ADDENDUM NUMBER: #1

Project Name: STARR COUNTY COURTHOUSE

TEMPORARY HOUSING INTERIOR BUILD-OUT

NOTICE TO ALL BIDDERS

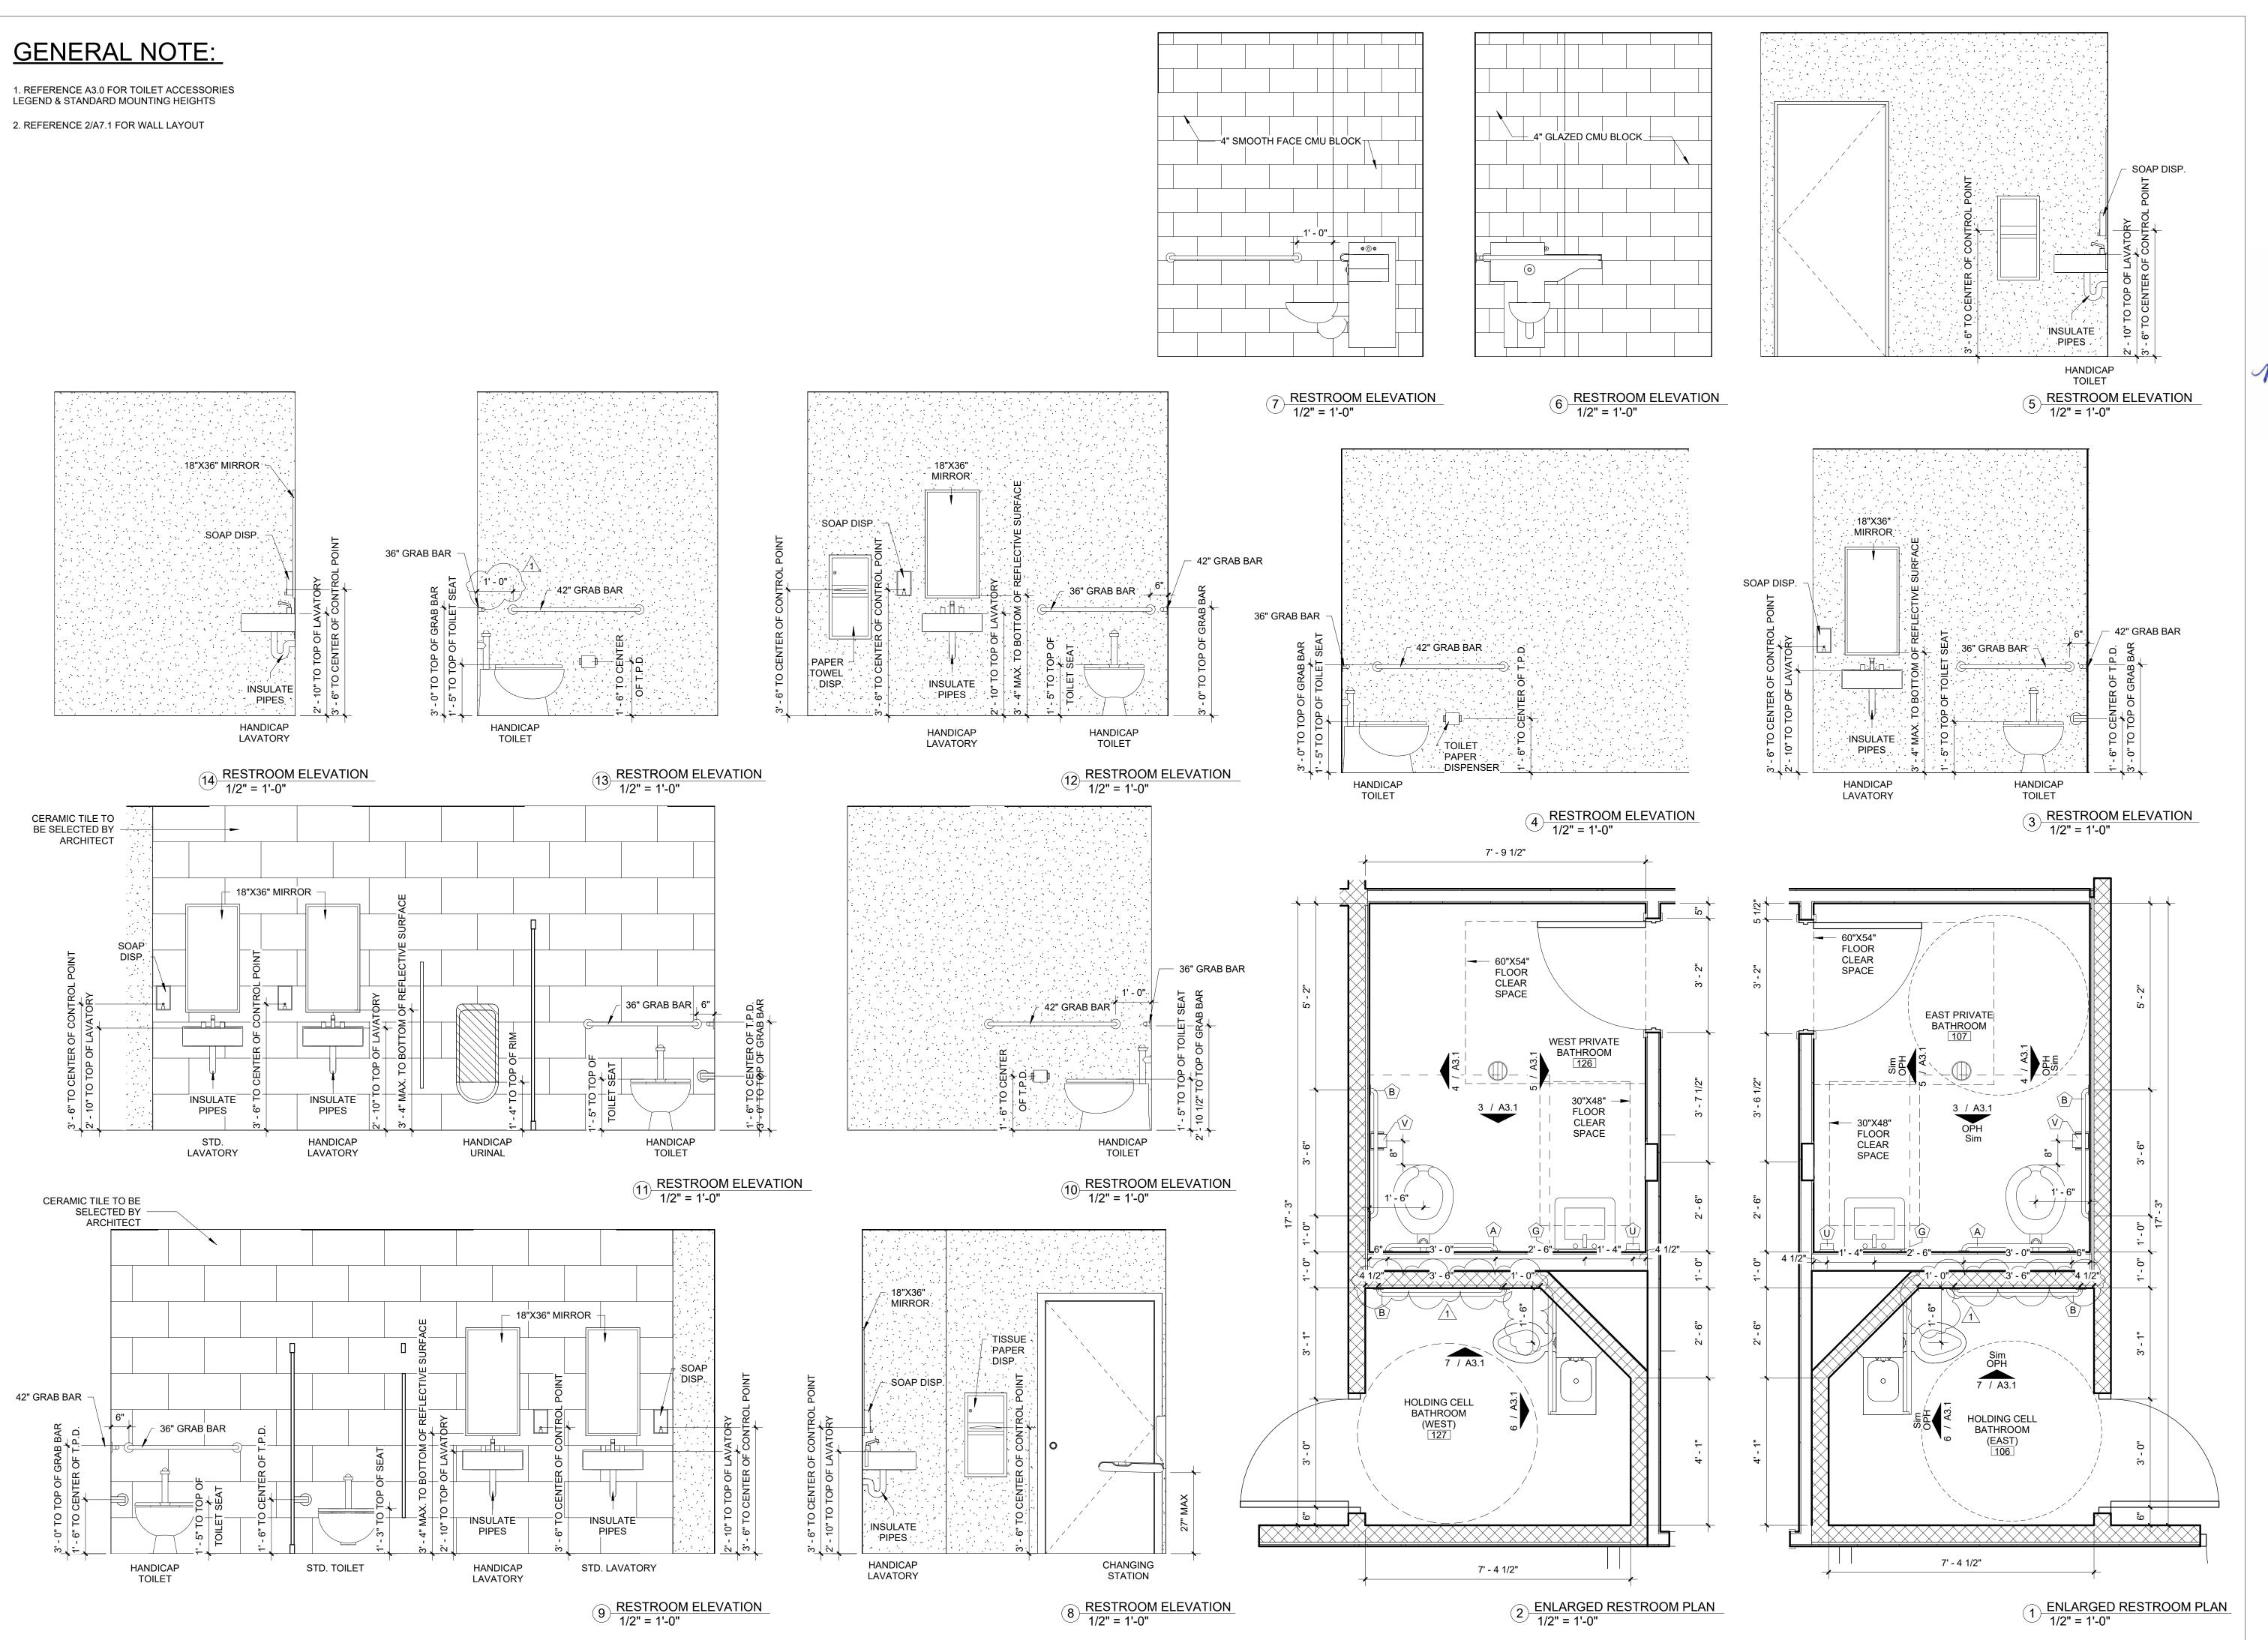
1.09 CORRECTION: Sheet A3.0- Enlarged Plans:

- ADA 42" grab bar adjusted to 1'-0" from the wall
- ADA toilet paper dispenser adjusted to 8" from the water closet
- Adjusted door in Men's R.R. to 4" from the wall
- ADA restroom partition adjusted to 5'-0"
- ADA restroom partition doors note added to be 3'-0" self-closing door
- ADA 36" grab bar adjusted to 6" from the wall
- ADA water closet adjusted to 1'-6" and added dimension
- Adjusted water closet, urinal, and partition, Ref: 1/A3.0 for new Dims.
- Adjusted framing at the north wall of the Men's Restrooms ADA stall

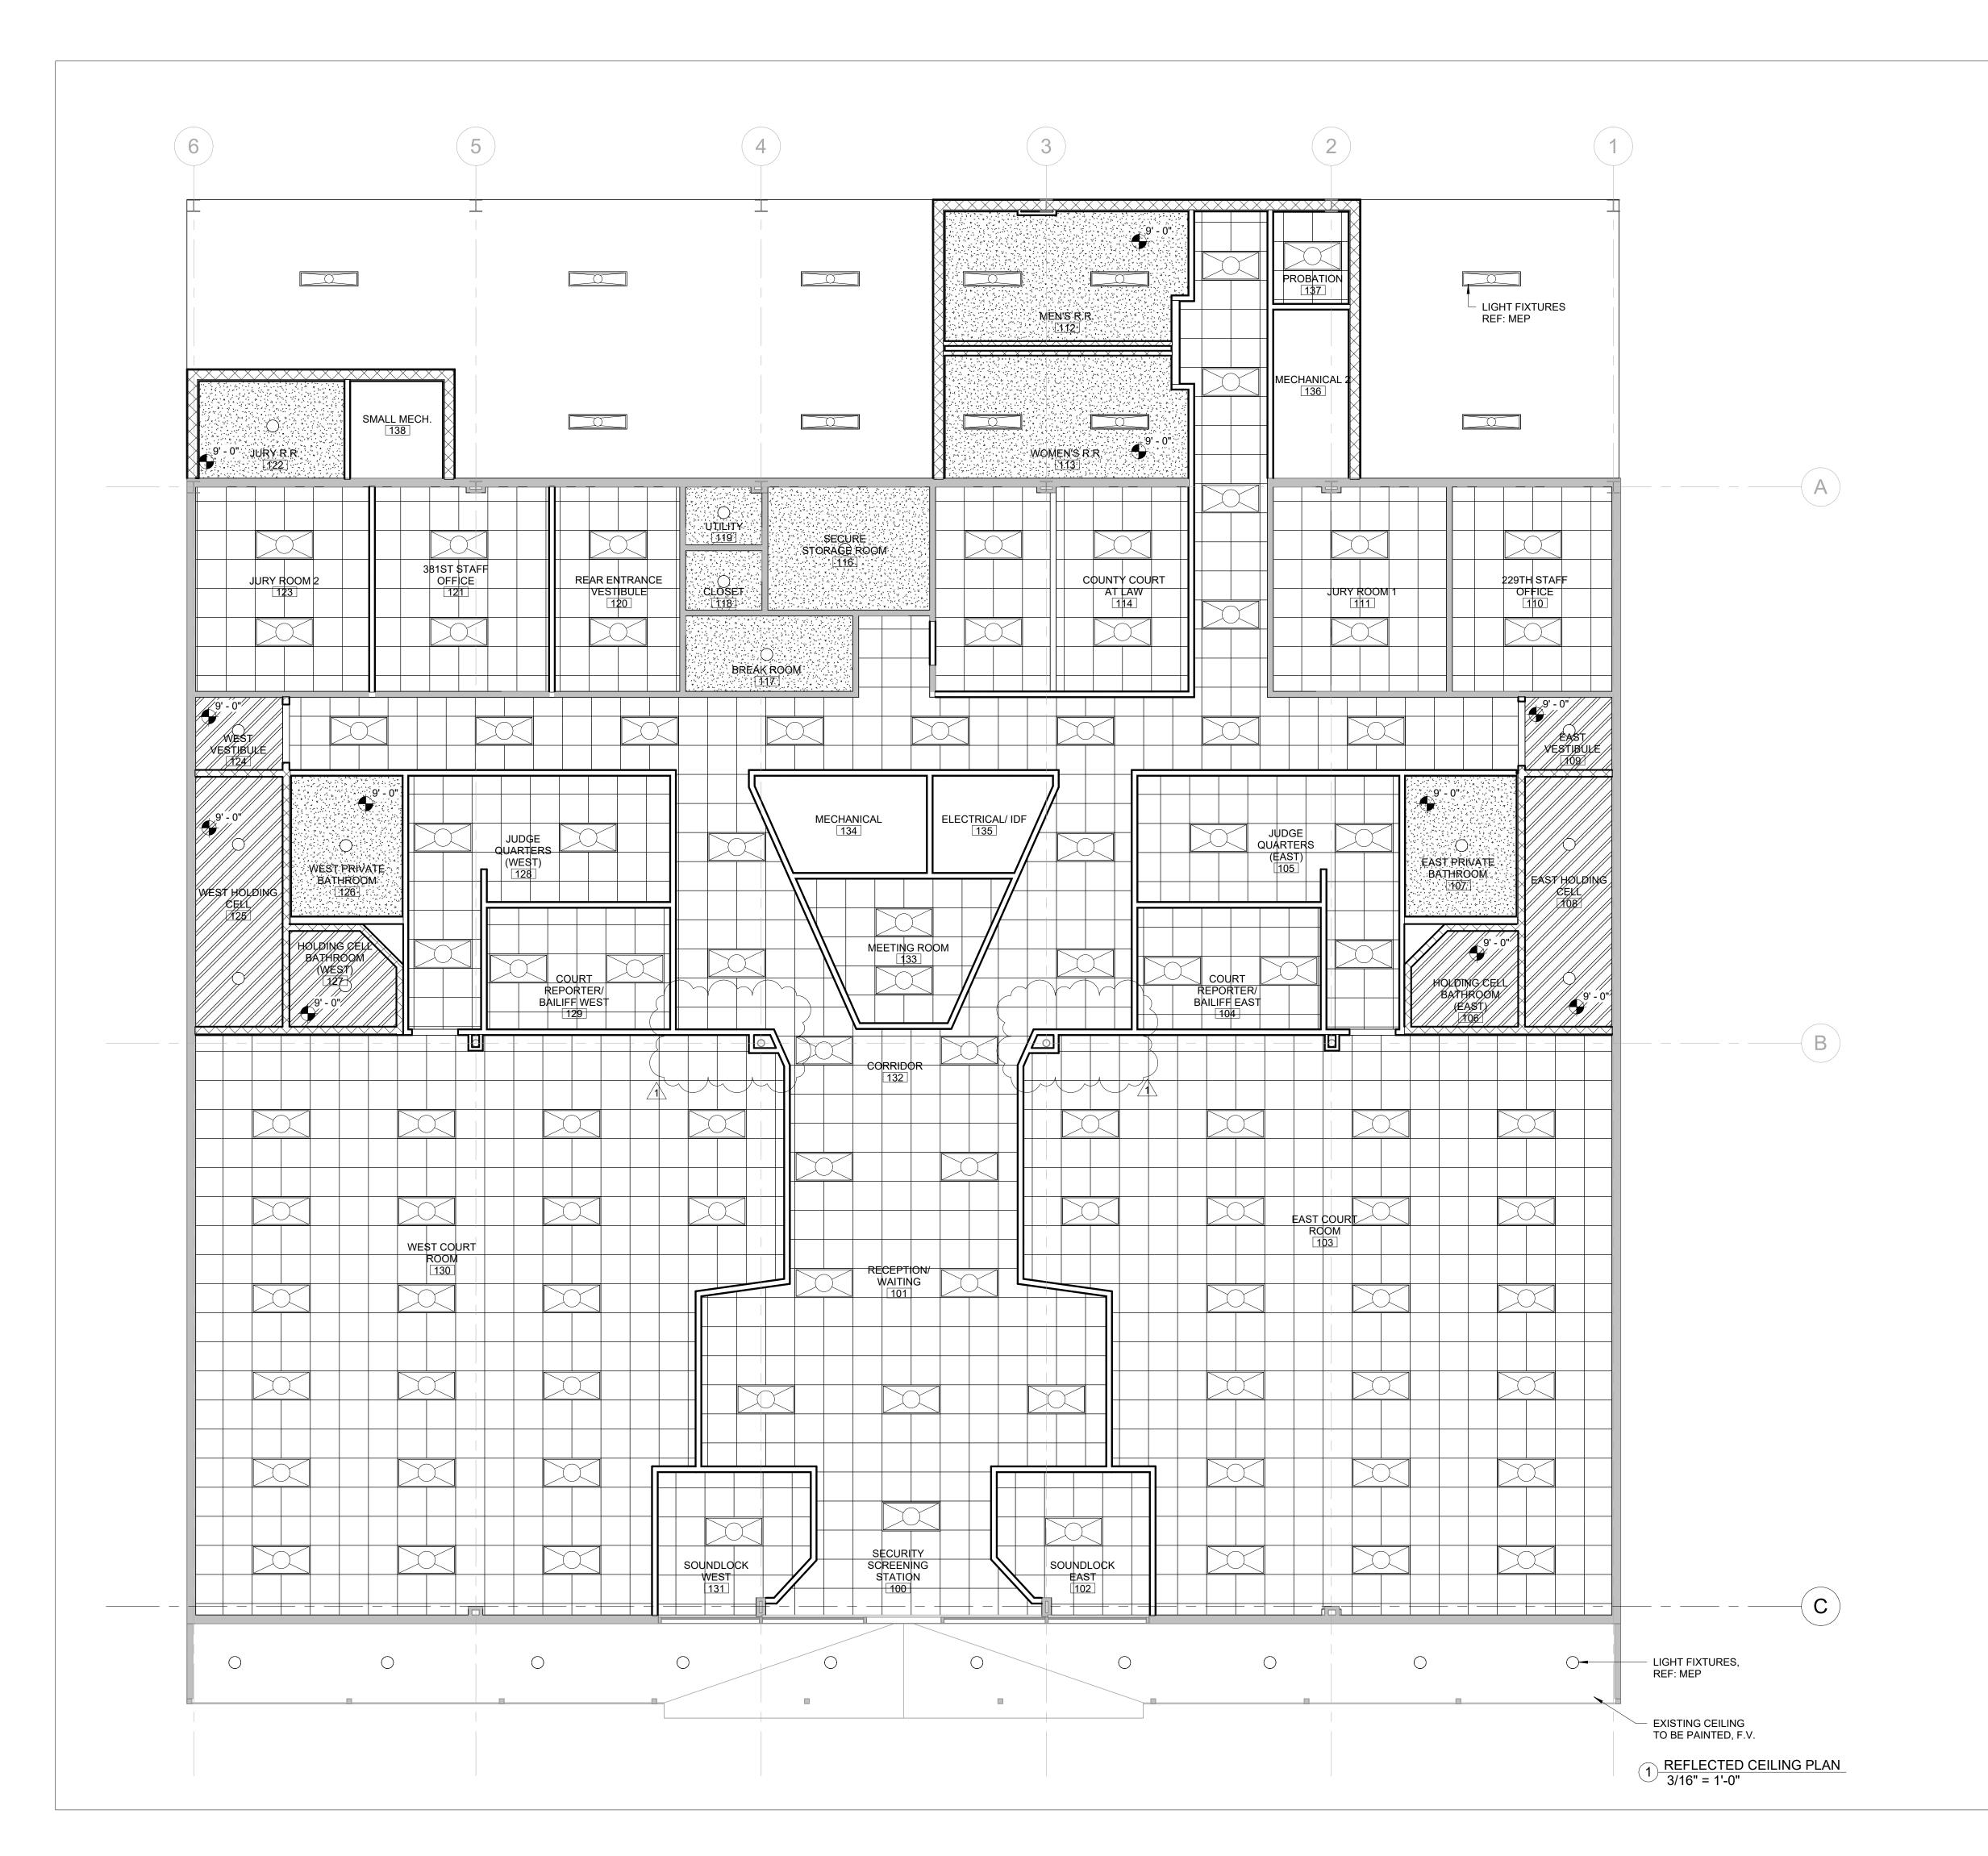
1.10 CORRECTION: Sheet A3.1- Restroom Elevations:

- ADA 42" grab bar adjusted to 1'-0" from the wall
- ADA water closet centered 1'-6" from wall, Ref: 1/A3.1 & 2/A3.1
- Added dimension to grab bar located in holding cell, Ref: 1/A3.1 & 2/A3.1

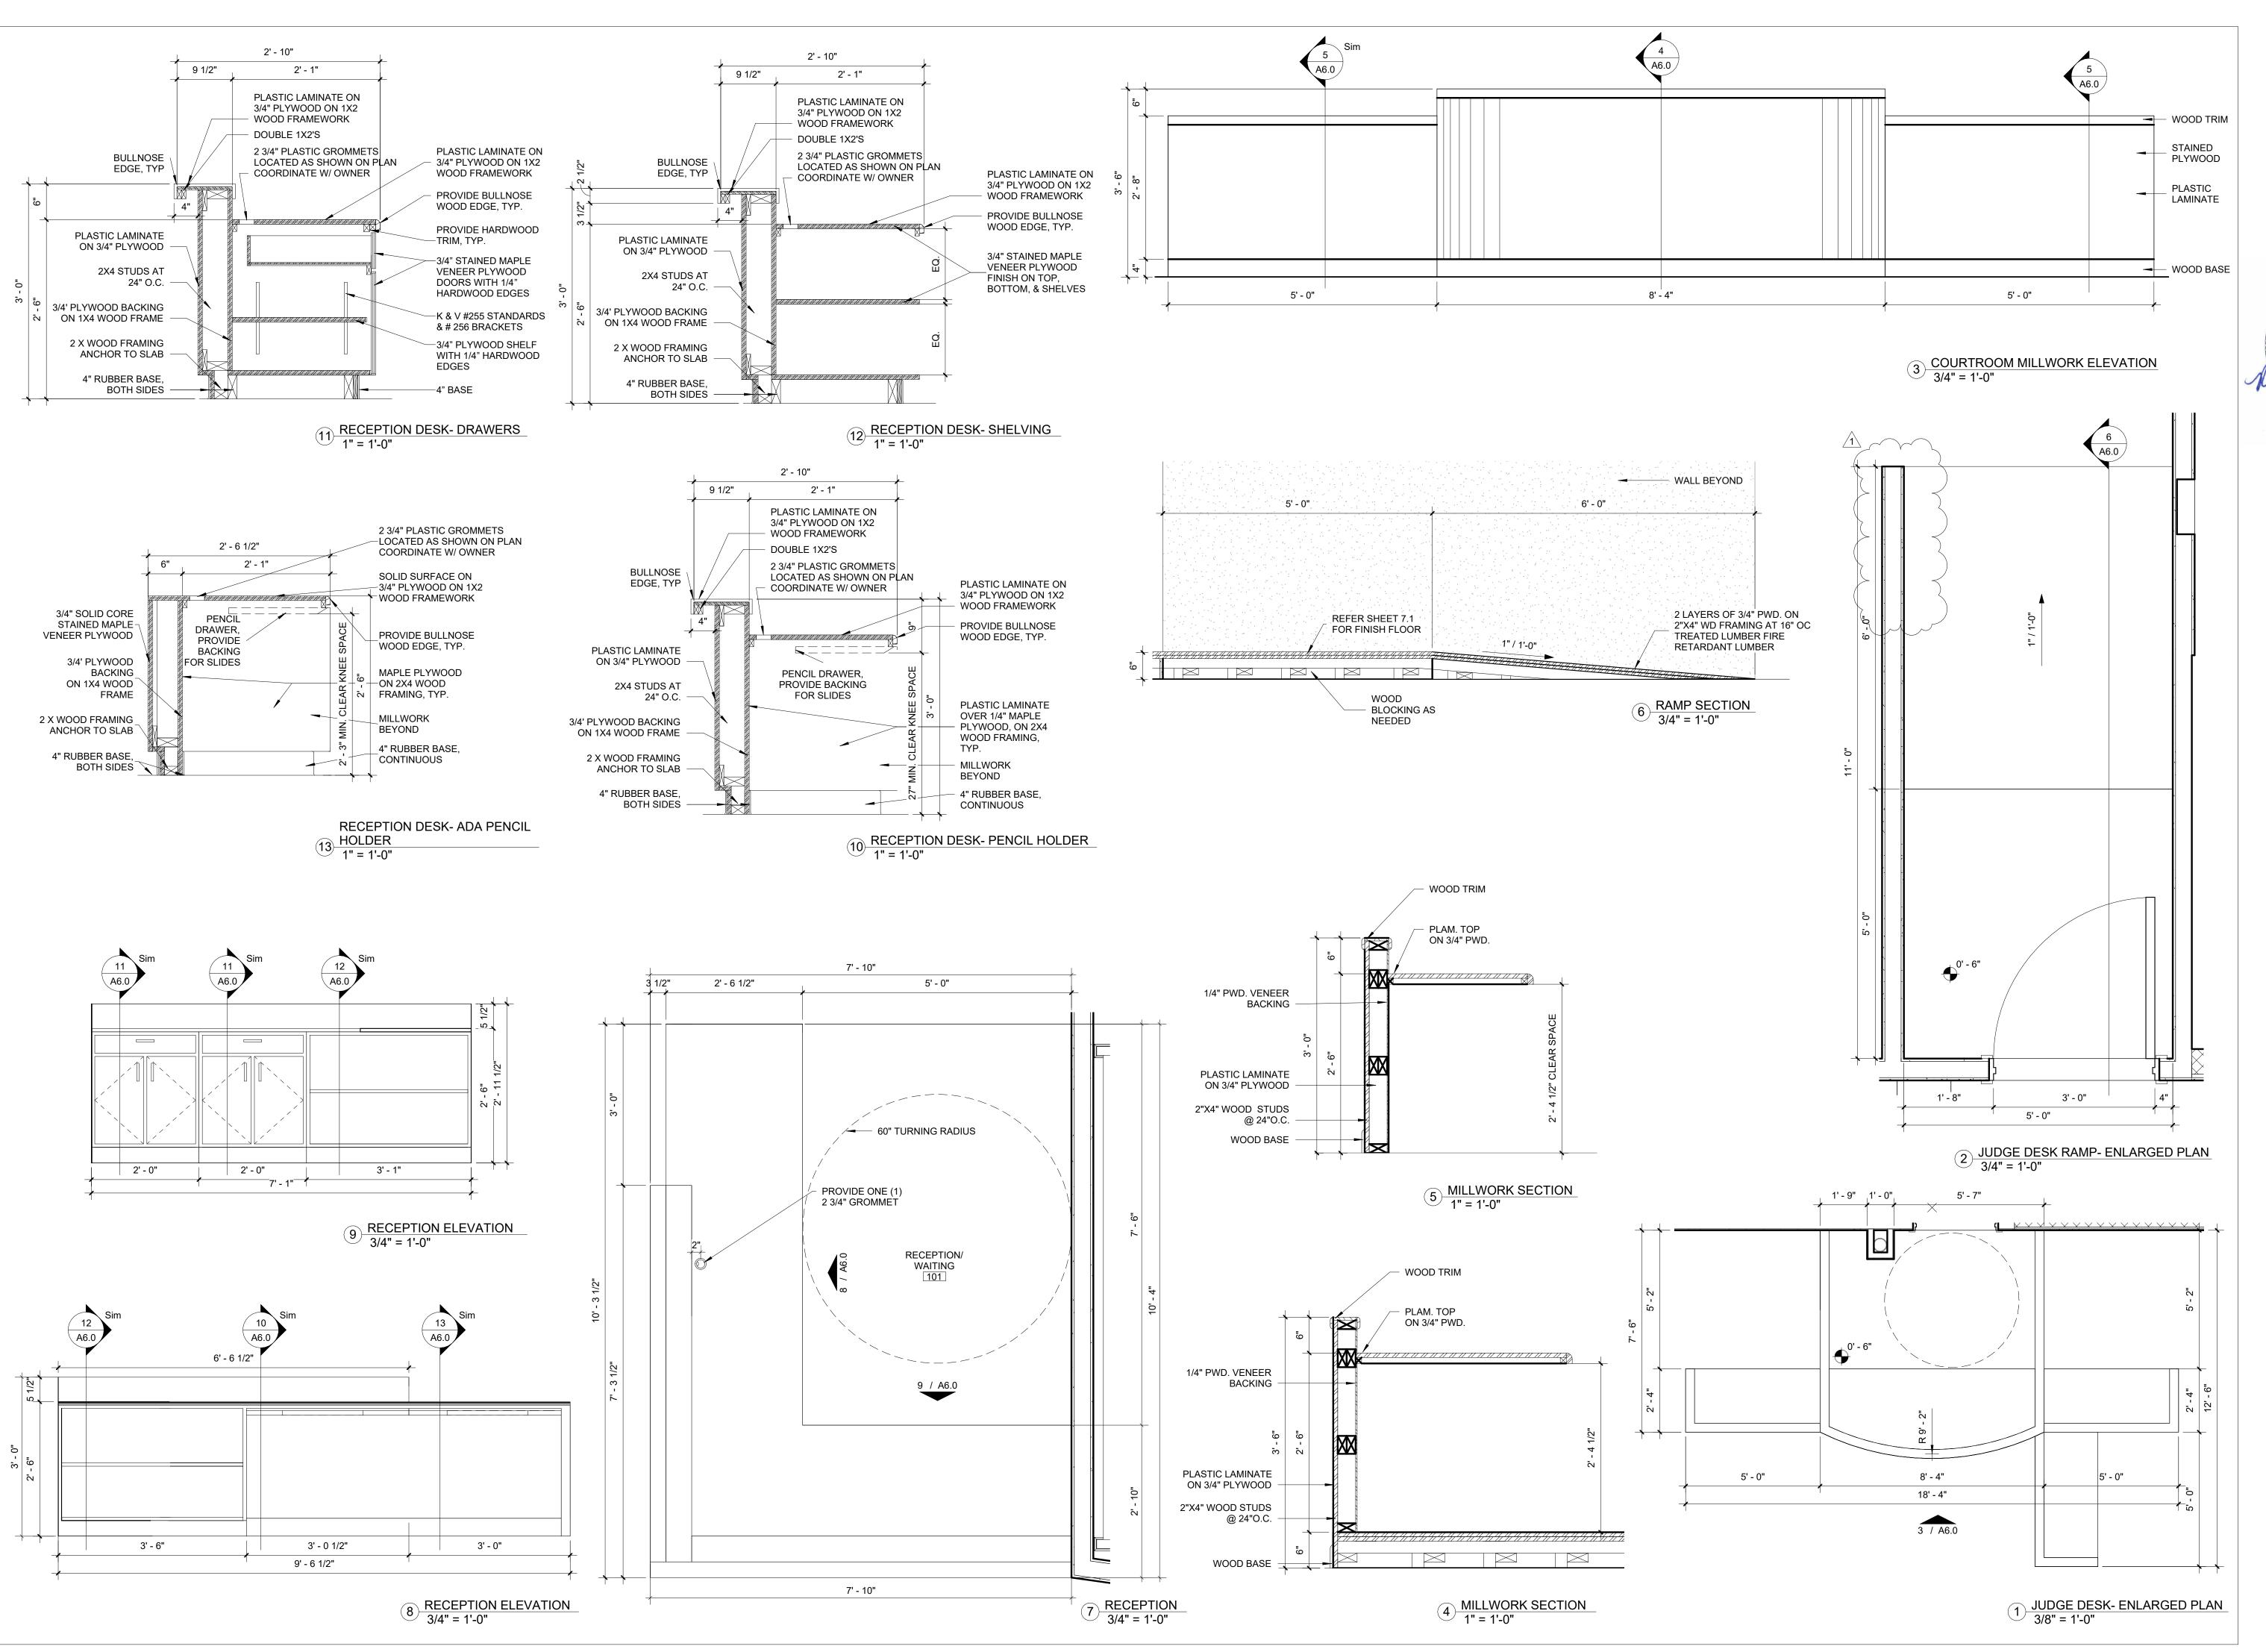
1.11 CLARIFICATION: Sheet A4.0- Reflected Ceiling Plan:

- Revised legend notes for the ceiling type in the holding cells
- Adjusted ceilings to match the new layout at jury box areas
